**Historic Landmark Commission  
October 24, 2011  
Permits in National Register Historic Districts  
NRD-2011-0080  
Pease Park  
1100 Kingsbury Street**

**SUBJECT: Update: Back-up Information for National Register Permit:  
Pease Park Improvements**

Figure 1: Pease Park Historic Tudor Cottage Restrooms constructed in the mid-1920s and attributed to architect Hugo Kuehne.

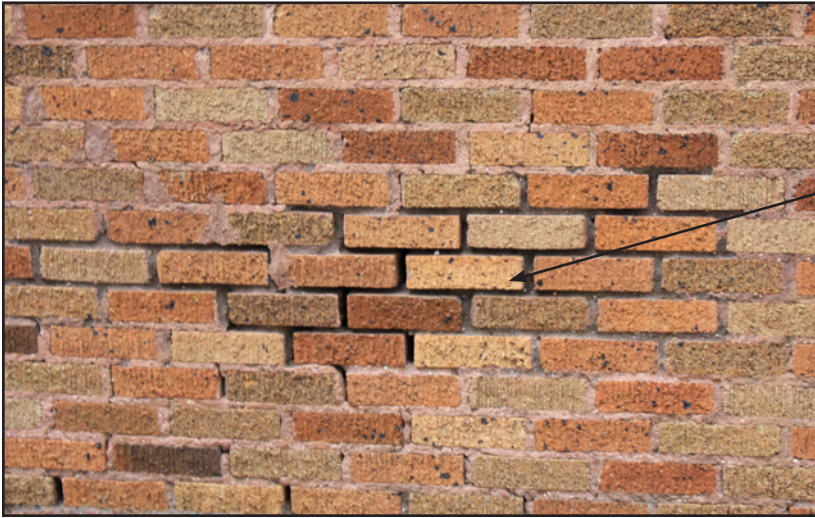
- b. Repair and restoration of historic concrete tables, benches, and bench legs at Pease Park (Fig. 12)
- c. Repointing of specific areas of the Historic Tutor Cottage Restrooms. The original pink limestone mortar has washed out and eroded from natural causes on different elevations of the cottage (Fig. 2). As a part of the repair process, the mason will prepare mock-up samples to be approved, using similar aggregate, color, and lime to match the historic mortar. Upon approval, the areas of missing mortar will be repointed and mortar joints will be finished and tooled to match the original design.

Figure 10: Sketches found on the back of original construction drawings for Pease Park Memorial Gates (Austin History Center).

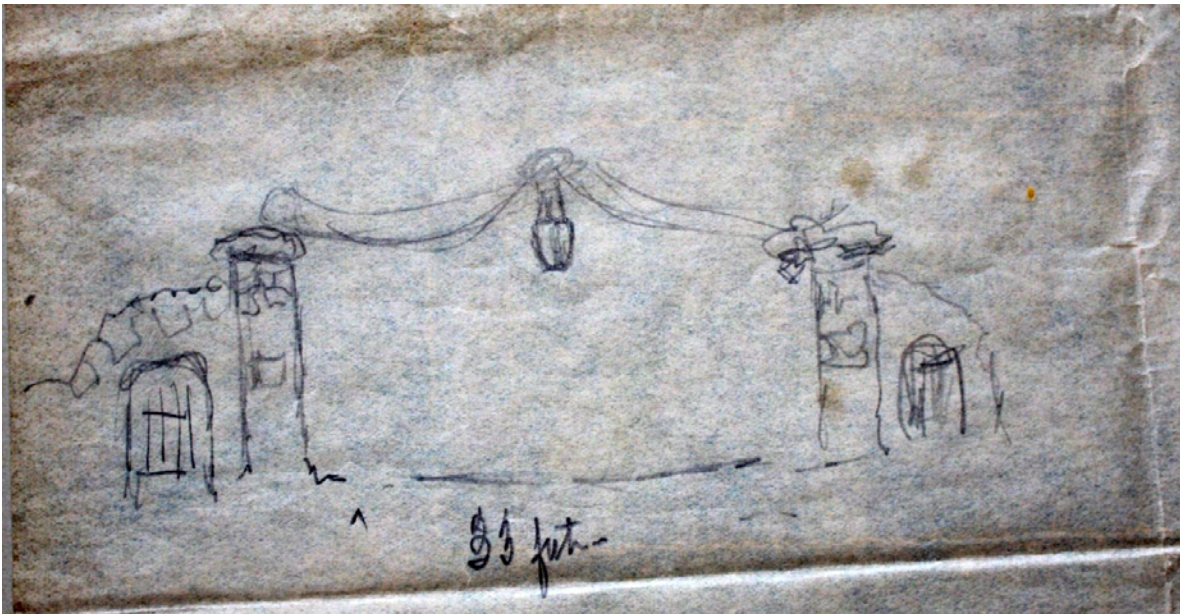
- b. **Considerations for Rehabilitation of Pease Park Memorial Gates:** It is not known to what extent the actual design of the Memorial Gates followed the construction drawings. Until historic photographs are located, the construction drawings are the best resource available. Original construction drawings, sketches and notations on the construction drawings are provided in Figures 8-11. The construction drawings, which are archived at the Austin History Center, specify a bronze plaque in the signage niches of the entry gates. Due to the fact the gates are somewhat isolated and theft of bronze and other metal material is a widespread problem, limestone may be considered as the material for the signage. Kim McKnight and representatives from the Pease Park Conservancy attended the Certificate of Appropriateness Committee on September 12. While a full discussion was cut short due to time constraints, early indications are that the commission would be open to limestone, but it was thought that bronze would be ideal. PARD looks forward to receiving feedback from the Historic Preservation Office and the Historic Landmark Commission. The lettering for the signage would be simple block letters similar to what is seen in the Aldridge Place signage (Figs. 13-18). In the meantime, all efforts should be made to locate early historic photographs that show the Memorial Gates.
